VI. PROPOSED TECHNICAL SPECIFICATIONS REVISIONS

The Technical Specifications for HNP-1 (Appendix A to Operating License DPR-57) are proposed for revision as presented in this section. Table 6.1 provides the instructions for incorporating the revision(s).

Overview of the Individual 10 CFR 50.92 Evaluations of the Proposed ATTS-Related Technical Specifications Changes for the Edwin I. Hatch Nuclear Plant-Unit 1

FIGURE 2.1-1
REACTOR VESSEL WATER LEVEL

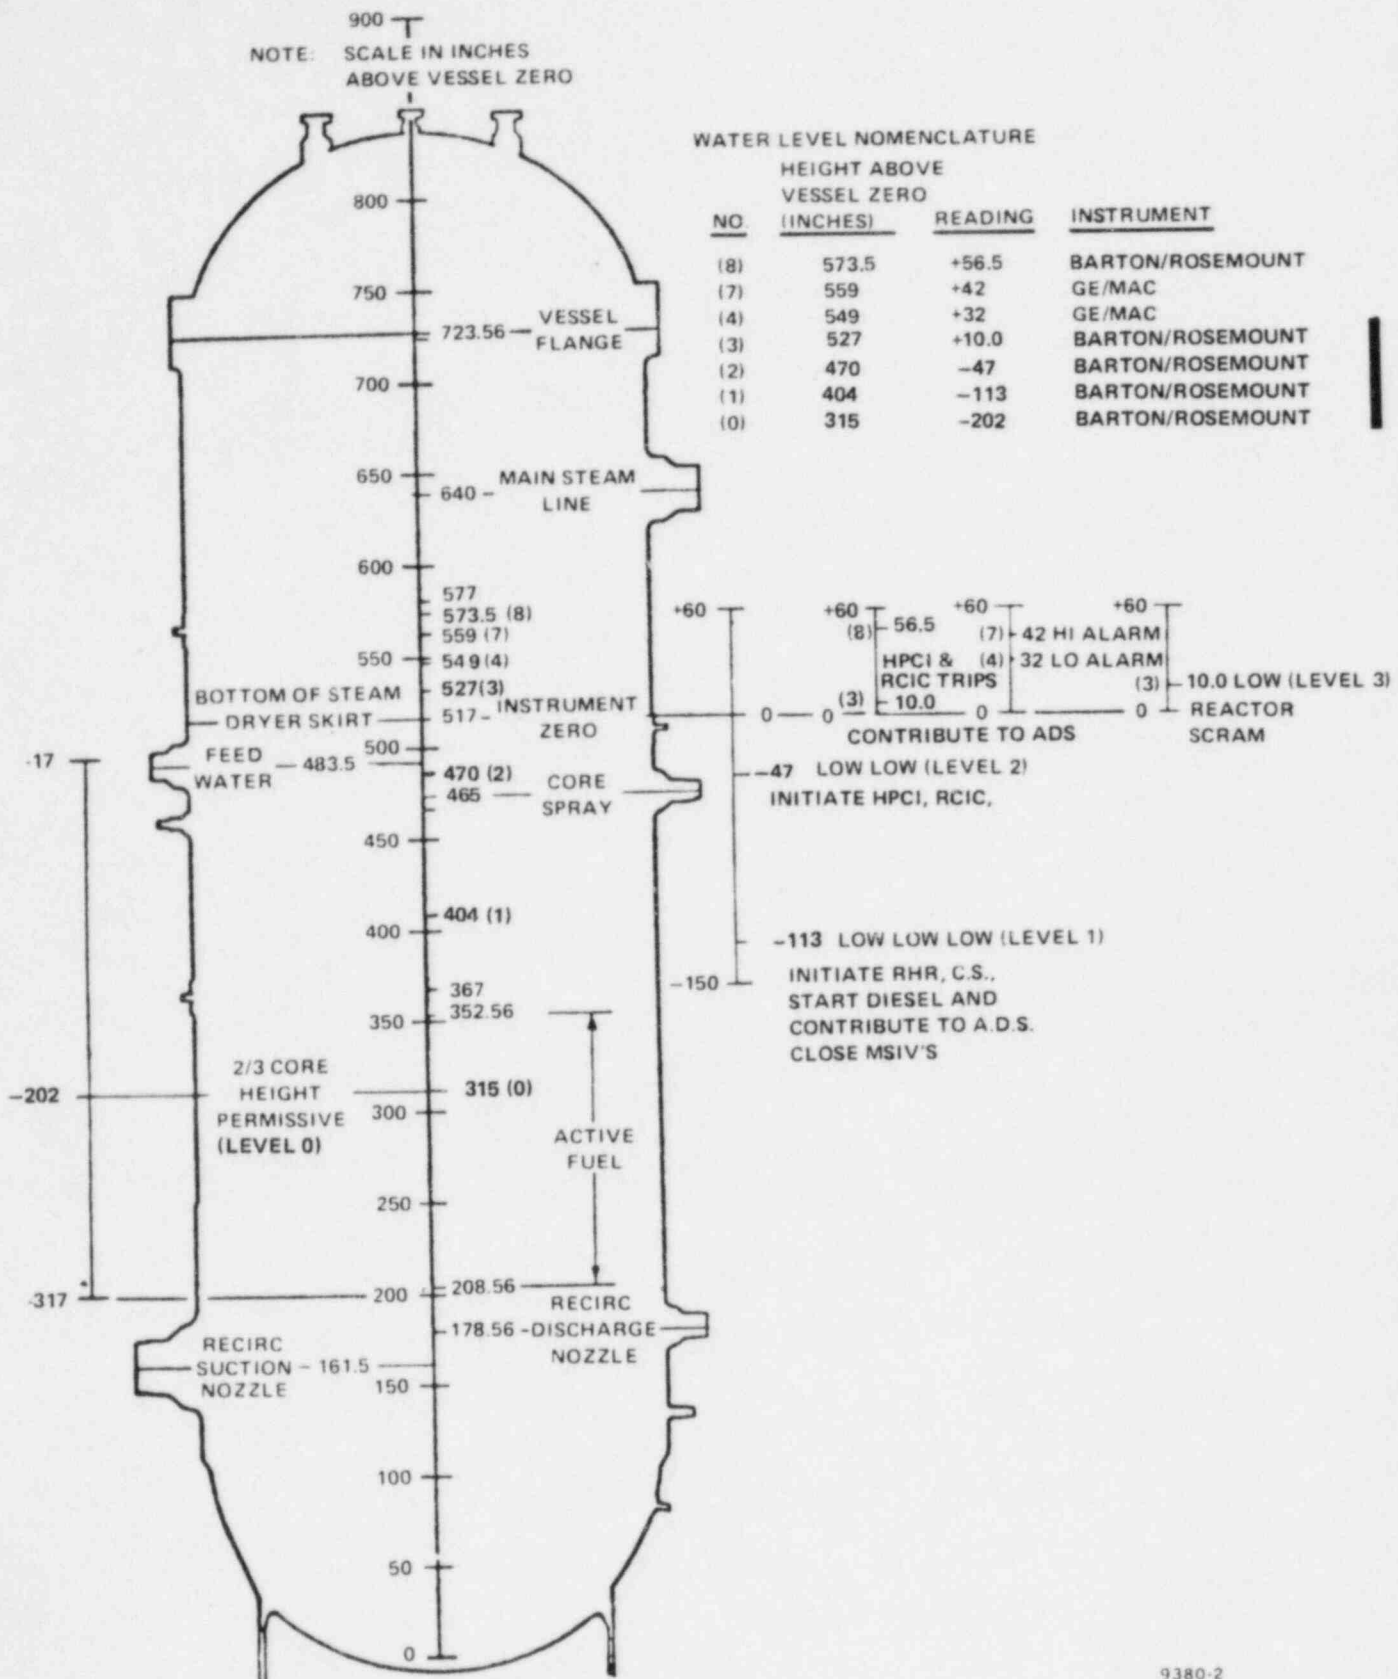
<u>Item</u>	<u>Deletions (Page)</u>	<u>Insertions (Page)</u>	<u>Applicable SER*(a) Section(s)</u>
1	1.1-3	1.1-3	4.B.4
2	1.1-5	1.1-5	4.B.4
3	Fig. 2.1-1	Fig. 2.1-1	4.B.4
4	1.2-2	1.2-2	4.B.7
5	1.2-6	1.2-6	4.B.7
6	3.1-4	3.1-4	4.B.4, 4.B.7
7	3.1-7	3.1-7	ATTS
8	3.1-12	3.1-12	4.B.7
9	3.2-2	3.2-2	4.B.4, 4.B.6, 4.B.7,
10	3.2-3	3.2-3	4.B.6, 4.B.7
11	3.2-5	3.2-5	4.B.4, 4.B.6, 4.B.7
12	3.2-6	3.2-6	4.B.6, 4.B.7
13	3.2-8	3.2-8	4.B.1, 4.B.4, 4.B.6, 4.B.7
14	3.2-9	3.2-9	4.B.6, 4.B.7
15	3.2-10	3.2-10	4.B.2, 4.B.4, 4.B.6, 4.B.7
16	3.2-11	3.2-11	4.B.2, 4.B.4, 4.B.5, 4.B.6, 4.B.7
17	3.2-12	3.2-12	4.B.6, 4.B.7
18	3.2-14	3.2-14	4.B.1, 4.B.4, 4.B.5, 4.B.6, 4.B.7
19	3.2-22	3.2-22	4.B.3, 4.B.6
20	3.2-24	3.2-24	ATTS, 4.B.6
21	3.2-25	3.2-25	ATTS, 4.B.6
22	3.2-27	3.2-27	ATTS, 4.B.6
23	3.2-28	3.2-28	ATTS, 4.B.6
24	3.2-30	3.2-30	ATTS, 4.B.6
25	3.2-31	3.2-31	ATTS, 4.B.6
26	3.2-32	3.2-32	ATTS
27	3.2-33	3.2-33	ATTS
28	3.2-34	3.2-34	ATTS
29	3.2-35	3.2-35	ATTS, 4.B.6, 4.B.7

- 2.1.A.2. Reactor Vessel Water Low Level Scram
Trip Setting (Level 3)

Reactor vessel water low level scram trip setting (Level 3) shall be ≥ 10.0 inches (narrow range scale). |

1. HPCI Actuation (Level 2)

HPCI actuation (Level 2) shall occur at a water level ≥ -47 inches. |

2. Core Spray and LPCI Actuation (Level 1)

Core Spray and LPCI actuation (Level 1) shall occur at a water level ≥ -113 inches. |
